REGIONAL REVIEW FINDING

ARC REVIEW CODE: R1809241

Name of Proposal: The Exchange at Gwinnett (DRI 2834)

Submitting Local Government: Gwinnett County

CONCEPTUAL SITE PLAN

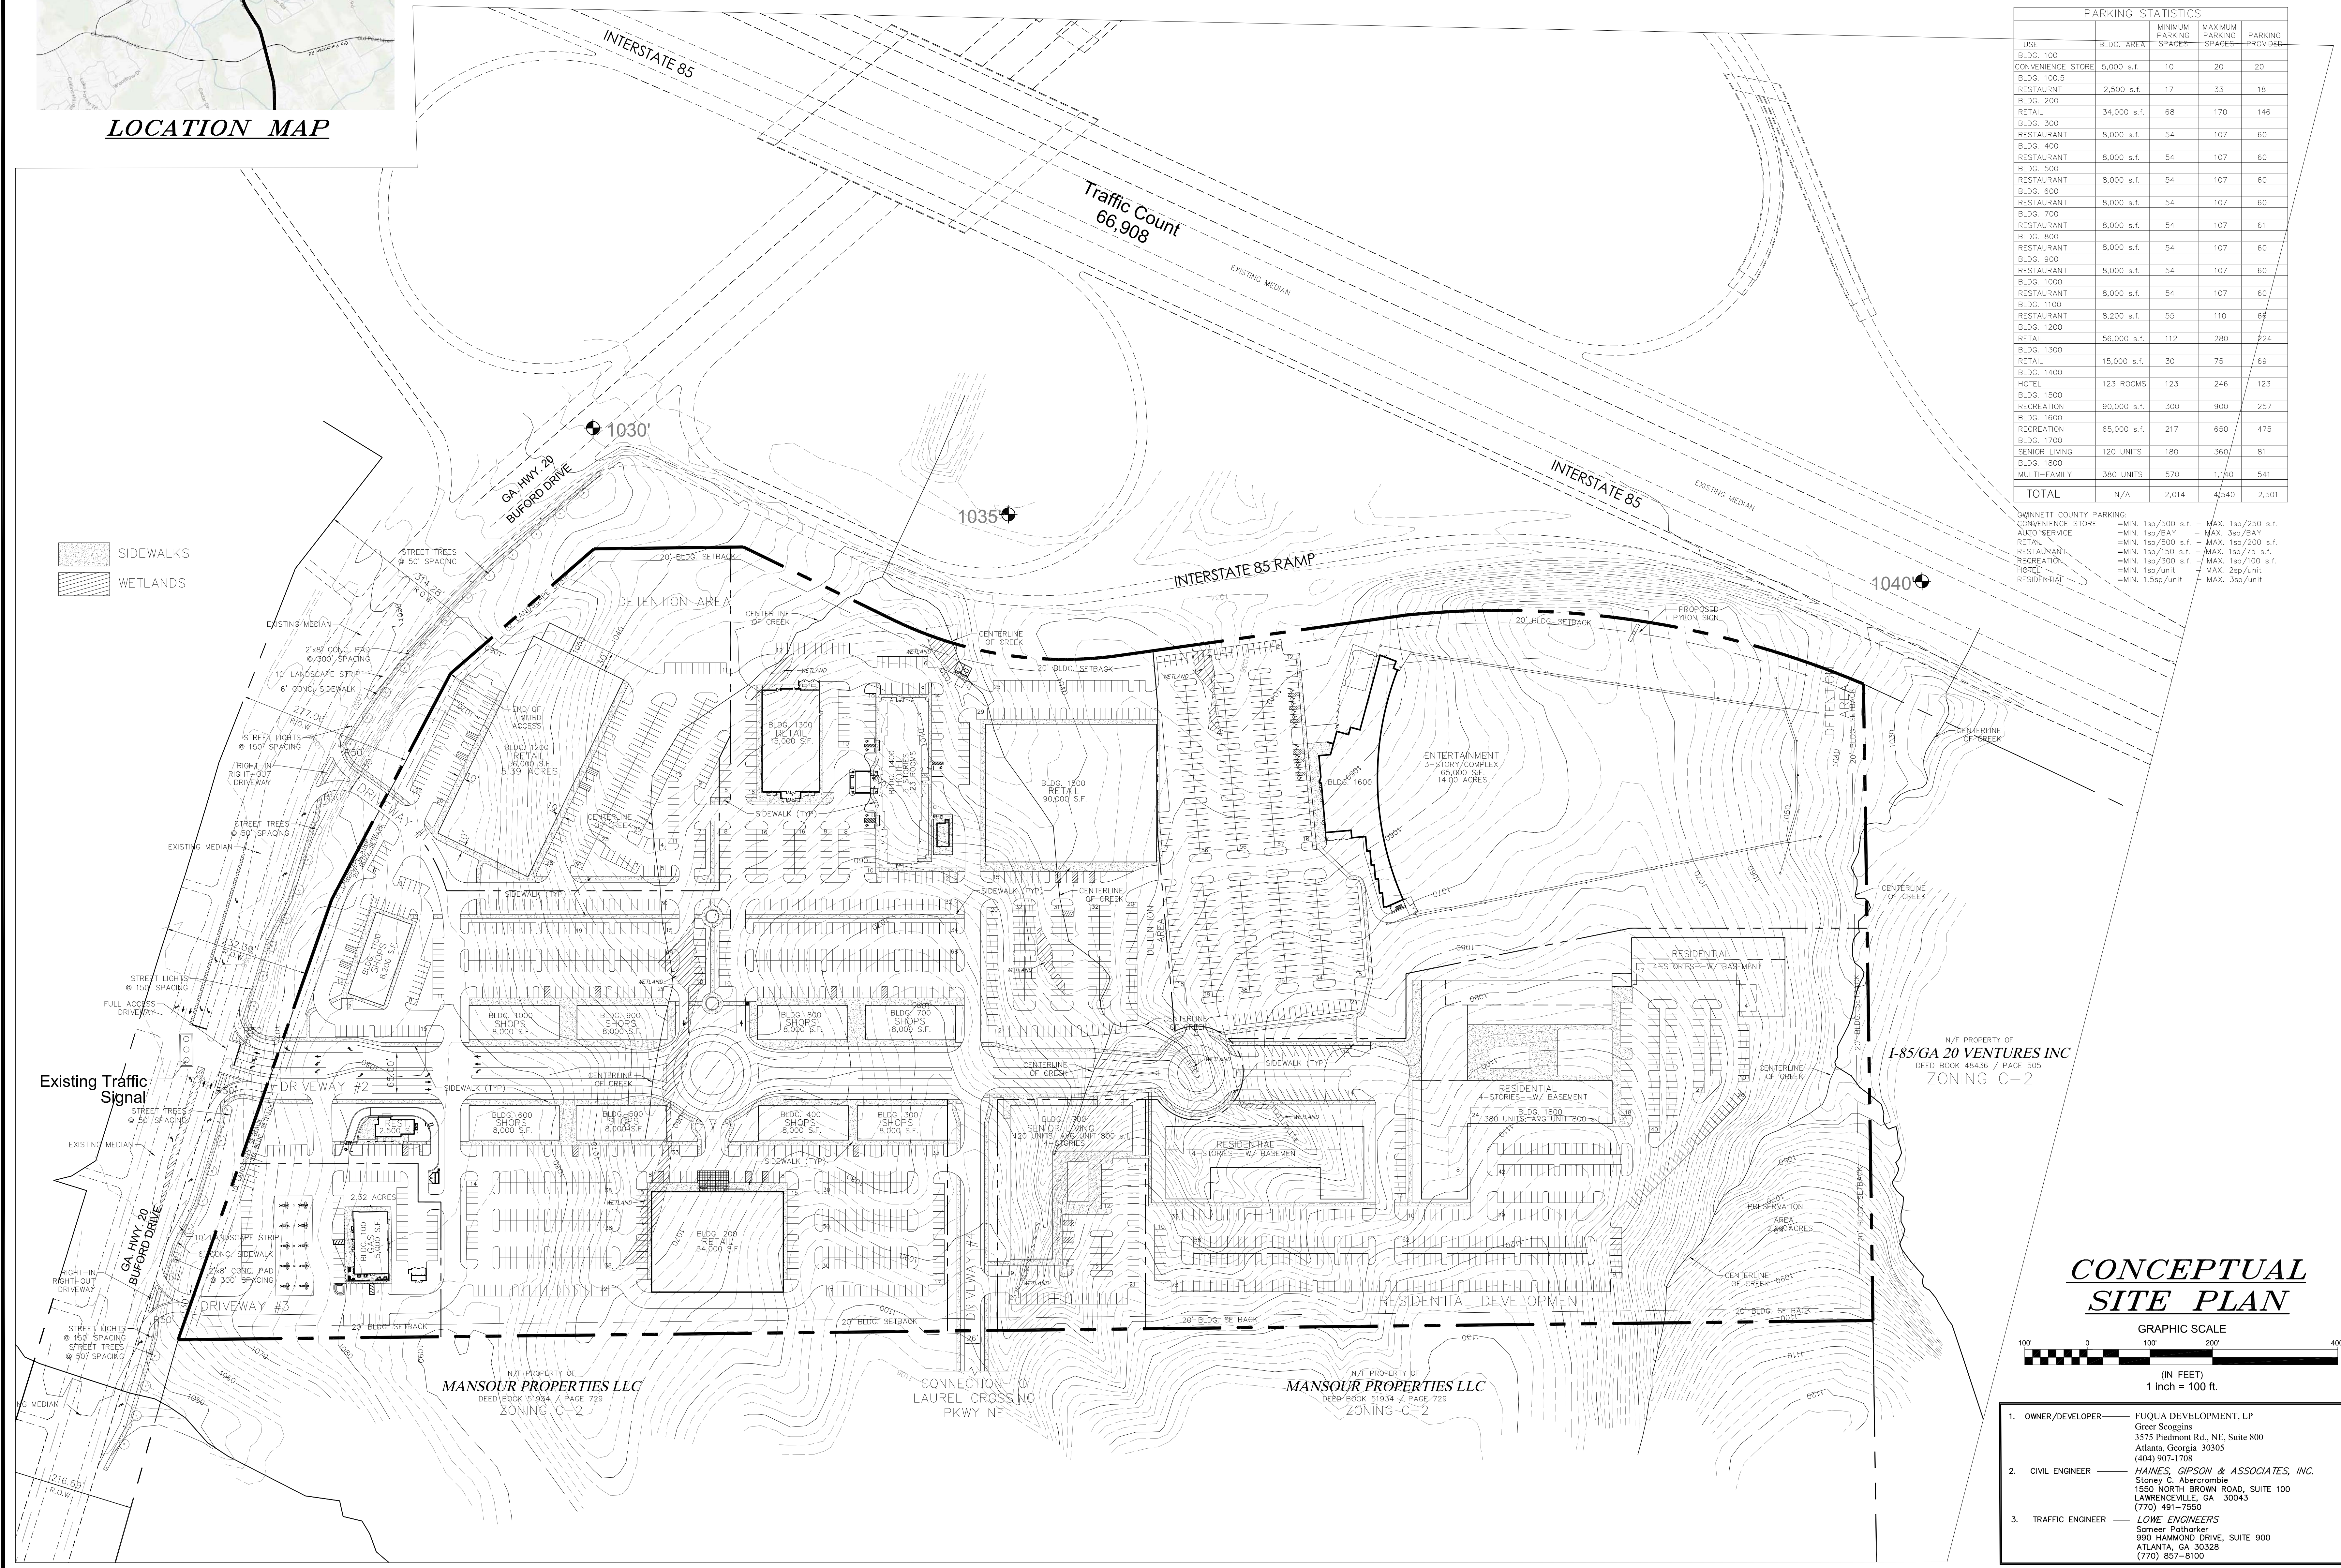
Additional ARC staff comments related to transportation and water resources, along with external comments received from contacted parties during the review period, are attached to this report. These include GDOT Aviation Division staff comments regarding the DRI's proximity to an air traffic navigation/signal facility and the resulting need for the development team to file an FAA Form 7460-1 at least 120 days before construction. Also included are GDOT District One staff comments relative to the DRI site plan. Of note are the need to consider the following: extending the right turn lane from Driveway 1 to the I-85 NB ramp; converting the first internal drives to right-in/right-out operation; extending the left turn lanes exiting the site at Driveway 2; and resolving the issue of dual left turn lanes entering the site at Driveway 2 into only one receiving lane (the outer lane dead ends into the raised median controlling NB right turns into Driveway 2).

- ? ICE will be required for the intersection of SR 20 @ Laurel Crossing Way
- ? Consider extending a right turn lane from the northern Right in right out drive to the I-85 Ramp
- ? Convert the first internal drives to right in right out and extend the left turn lane for the signal
- ? The NB right turn lane on SR 20 will have to be signal controlled. You are showing dual lefts into the development, but have a raised island preventing one from entering.

Both the submitted site plan and the USGS coverage for the project area show a tributary of Ivy Creek crossing the eastern side of the project property. A second tributary to Ivy Creek is shown on the site plan just to the south west of the project property. Ivy Creek is a tributary of Suwanee Creek, which flows to the Chattahoochee River. No buffers are shown for either stream. All streams on the property, including unmapped streams, are subject to the requirements of the Gwinnett County Stream Buffer, which include a 50-foot stream buffer and additional 25-foot impervious setback on most streams. All mapped or unmapped waters of the state on the property, including all streams, are also subject to the State 25-foot Sediment and Erosion Control buffer. All required buffers on the property should be shown on the site plan. Any development activity within the County buffer or setback may require a variance from the County. Any activity in the State 25-foot Erosion and Sedimentation buffer may also require a variance.
